ANNEX B: Product Change Description

BG96 R1.1 & BG96 R1.2 Differences Statement

PCB Rev.: R1.2

Date: 2018-10-08

Figure 1: Schematic Designs of BG96 R1.1 and R1.2

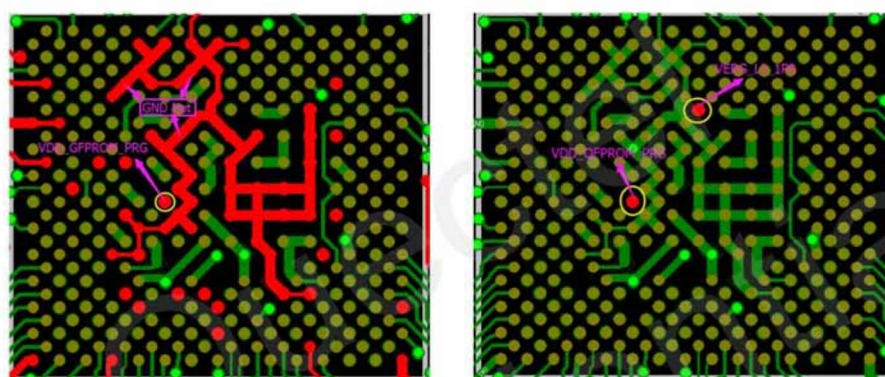
The VDD_QFPROM_PRG (N19) pin of baseband chip is for secure boot function. In BG96 R1.1, this pin is connected to ground directly, which means secure boot function is disabled.

According to Qualcomm's suggestion and our customers' requirements, the VDD_QFPROM_PRG pin is connected to VREG_L3_1P8(1.8V) in BG96 R1.2 so as to enable secure boot function.

The following pictures show the schematic and PCB designs of BG96 R1.1 and R1.2.
